DRB Application No.: 04DRB-00527-~~(P&E)~~^{SBP} Project # 1003370
 Project Name: ALAMEDA BUSINESS PARK
 Agent: Schlegel Lewis Architects Phone No.: 247-1529

**CITY OF ALBUQUERQUE
PLANNING DEPARTMENT
Development Review Board
April 14, 2004
Comments**

RE: Tract 28, Alameda Business Park/SPBP

Site Development Plan for Building Permit
8700 Alameda Park Warehouse
8700 Alameda Park Drive NE
Albuquerque New Mexico 87113

Elevations
 PROJECT 0406 SHEET
SDP-5
 OF 5

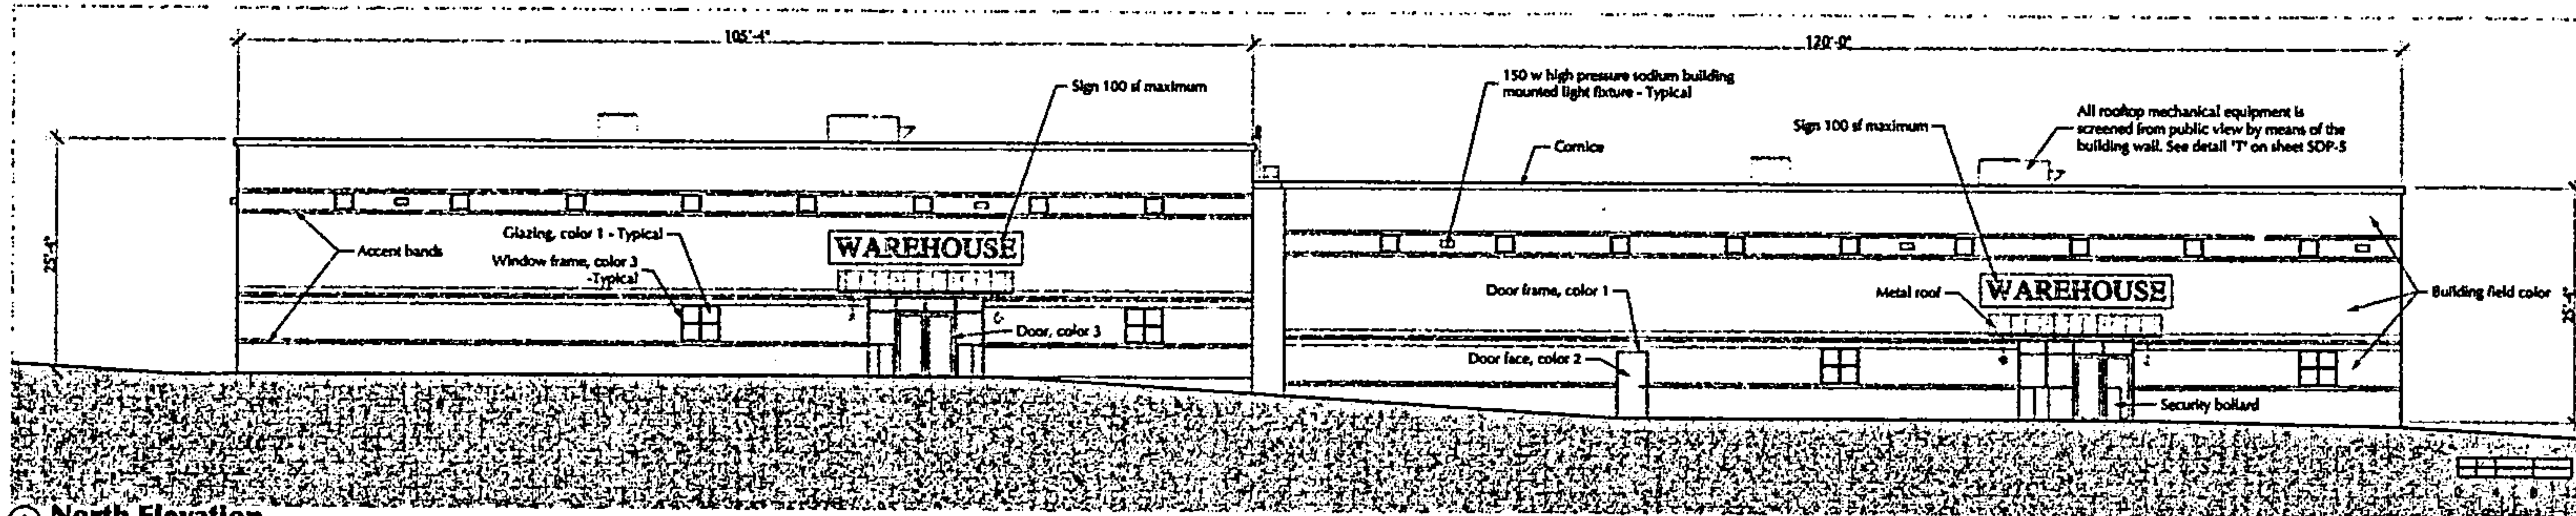
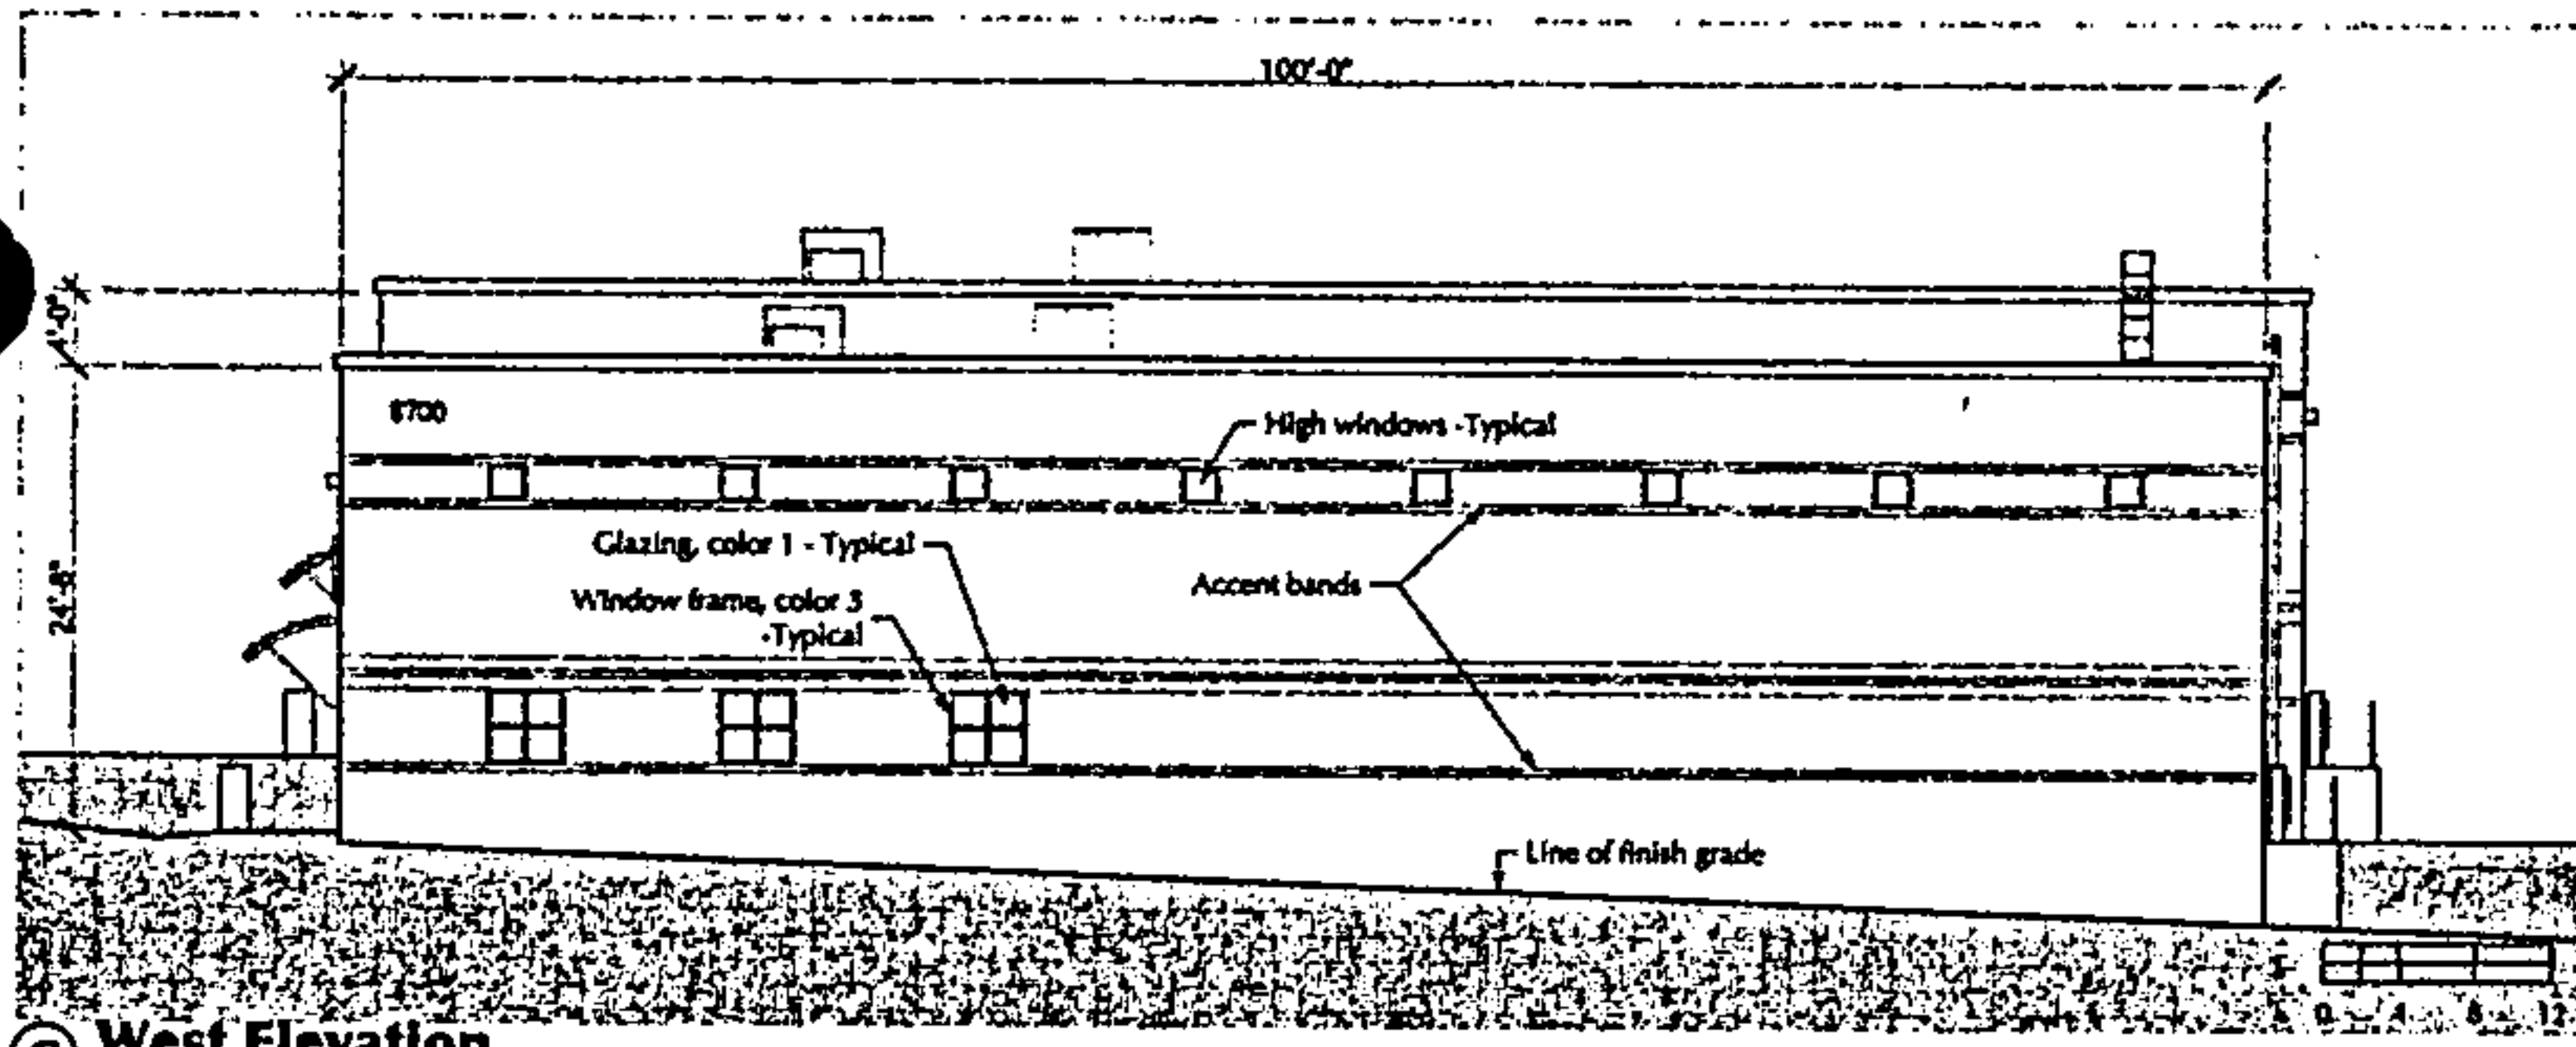
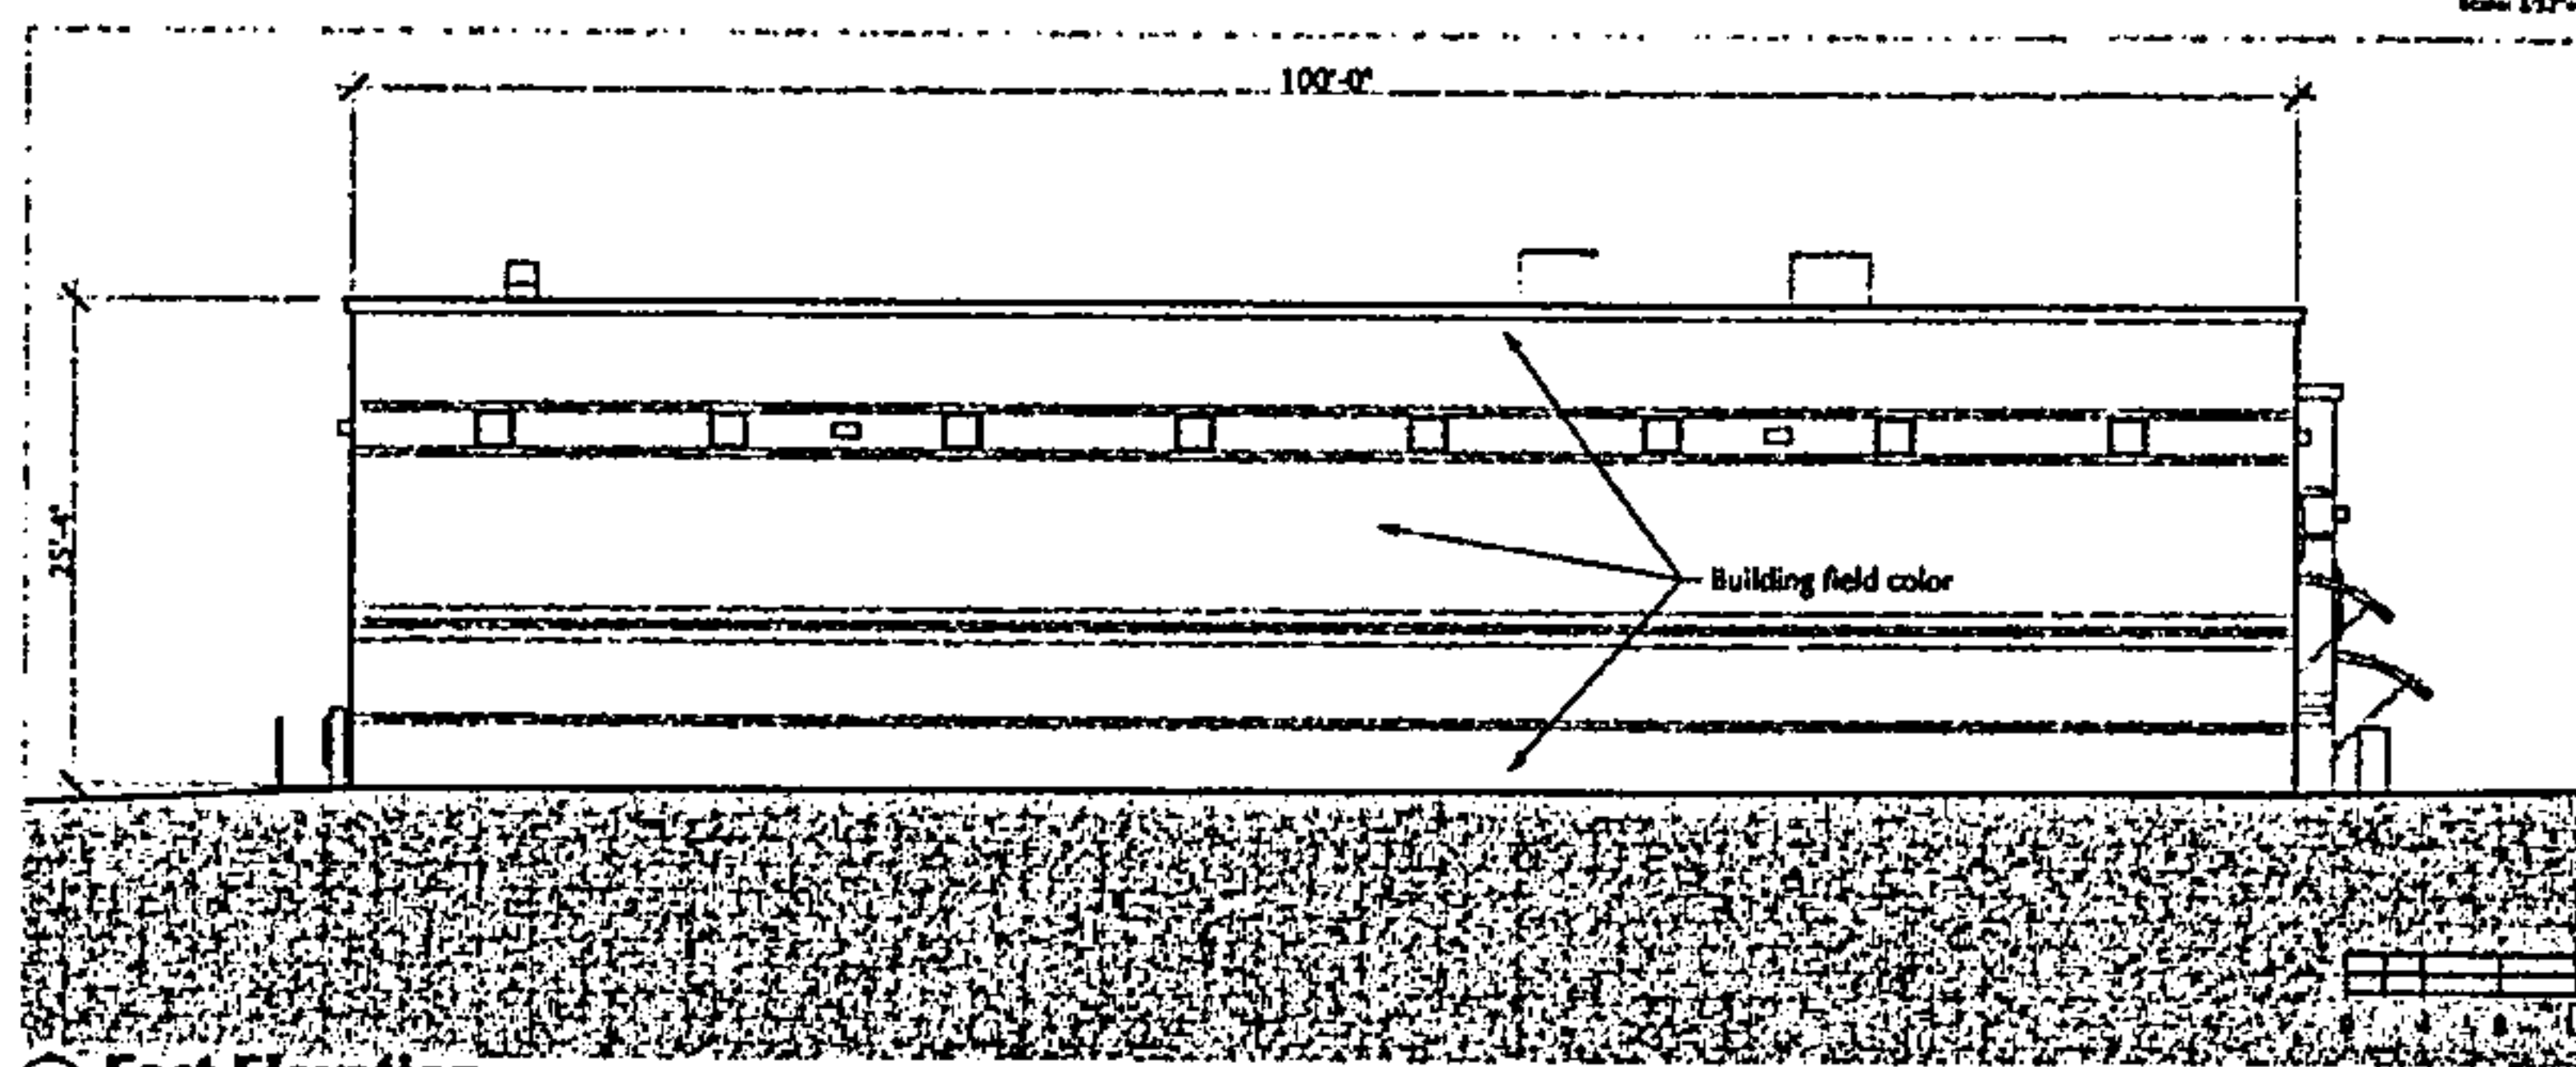
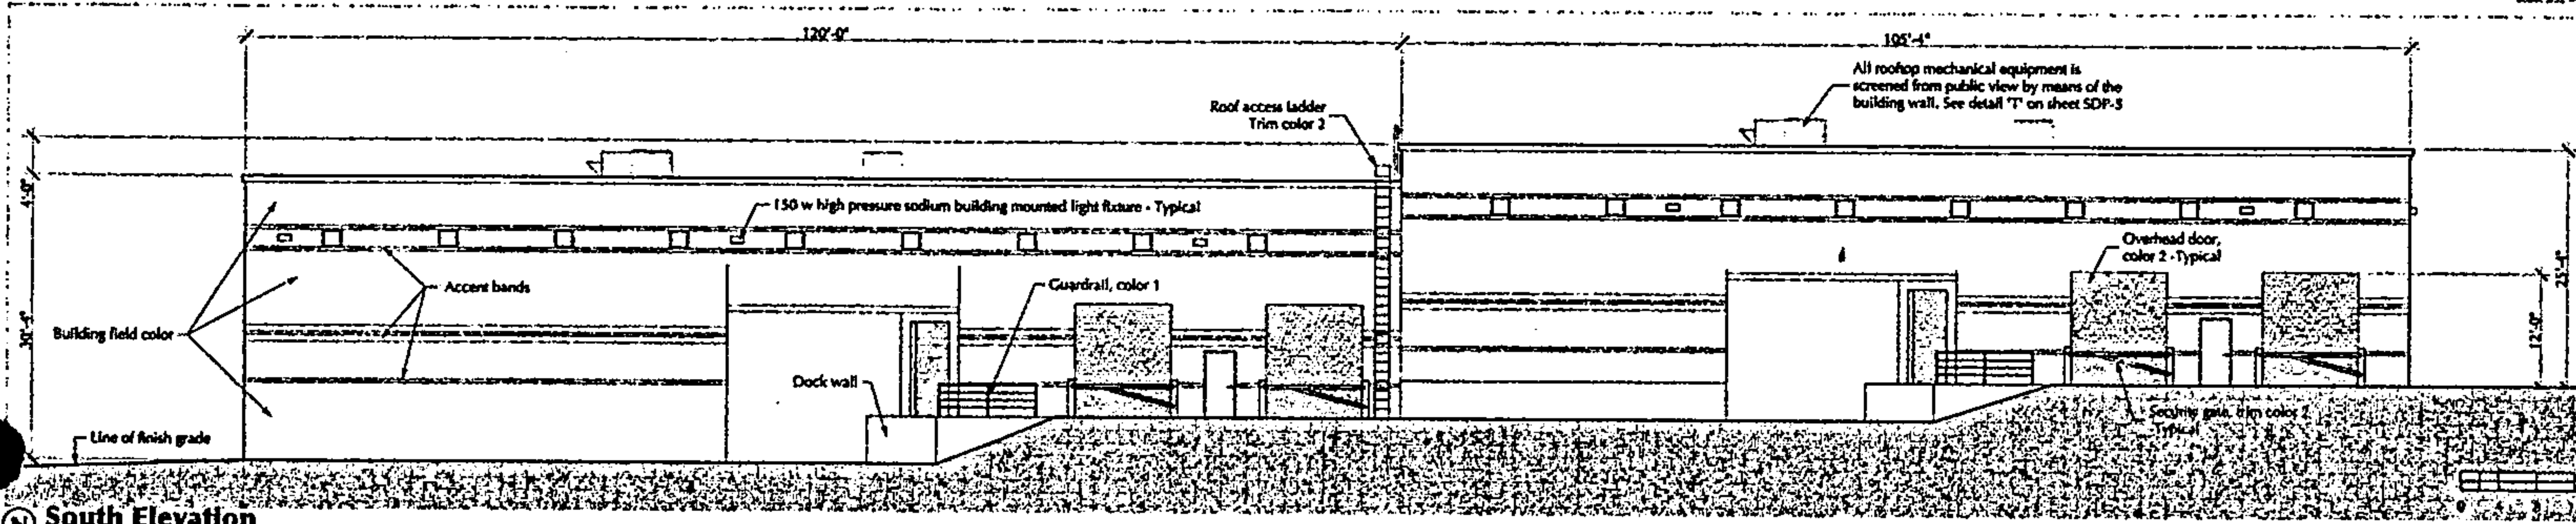
7. Building Mounted Sign. The Master Plan states that this sign shall not exceed 3'6" in dimensional height of any portion of the sign. This note should be placed on the elevations sheet where the building mounted sign appears.

- ✓ 8. Materials of windows, doors & framing are required on the elevations sheet.
- ✓ 9. Both signs must have dimensions and square footage as well as materials & colors.

V Sign Elevation

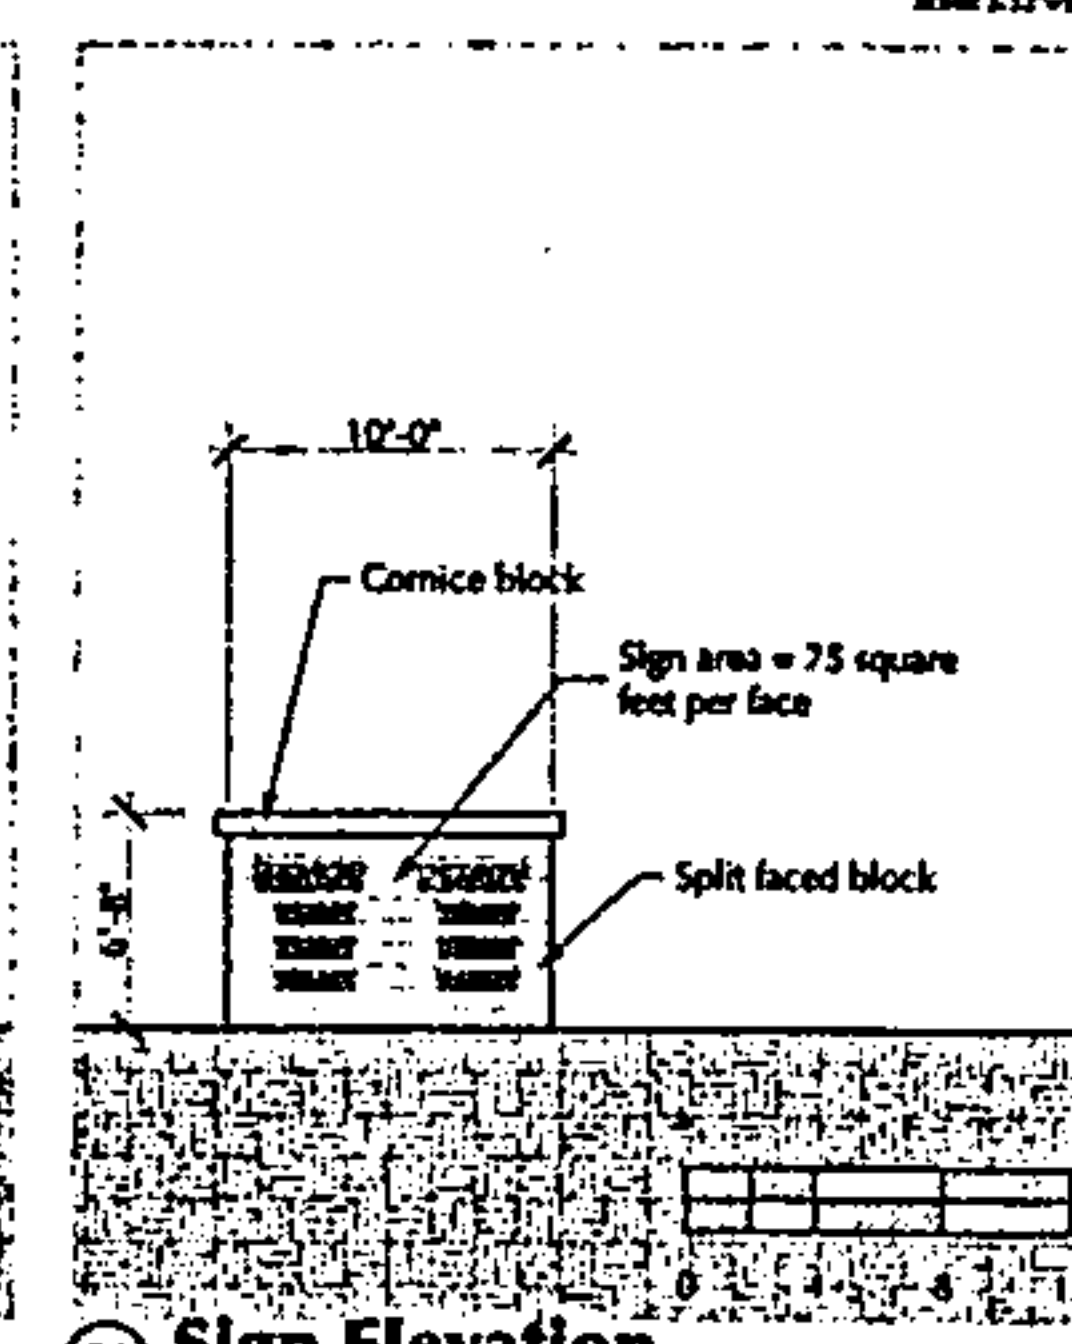
9. Both signs must have dimensions and square footage as well as materials & colors.
